### **FIELD SERVICE BULLETIN**

FSB Number: LVCCFSB2004-155  
Author: Hien Huynh  
Date: July 20, 2004  
Total No. of Pages: 3  
Subject: **GSM E398 – Loose Battery door fit.**  
Model Affected: E398  
Level of Repair: 2

**Photo & part numbers are shown below for reference:**

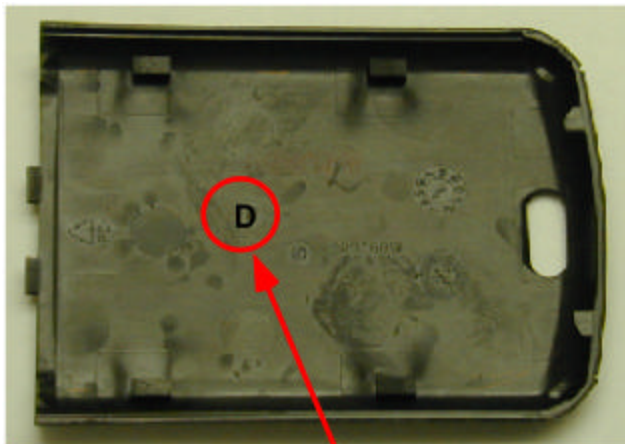
Corrective action was implemented to improve Battery door fit:

- Battery door revision "O" or "B" with battery door revision "D"; *fixed Z, X and Y axis movement.*

Battery door Revision is located here

Battery Door	Part number
Soft touch Black	SHN8650A
Cosmic Universe Blue	SHN8649A
Star White	SHN8651A
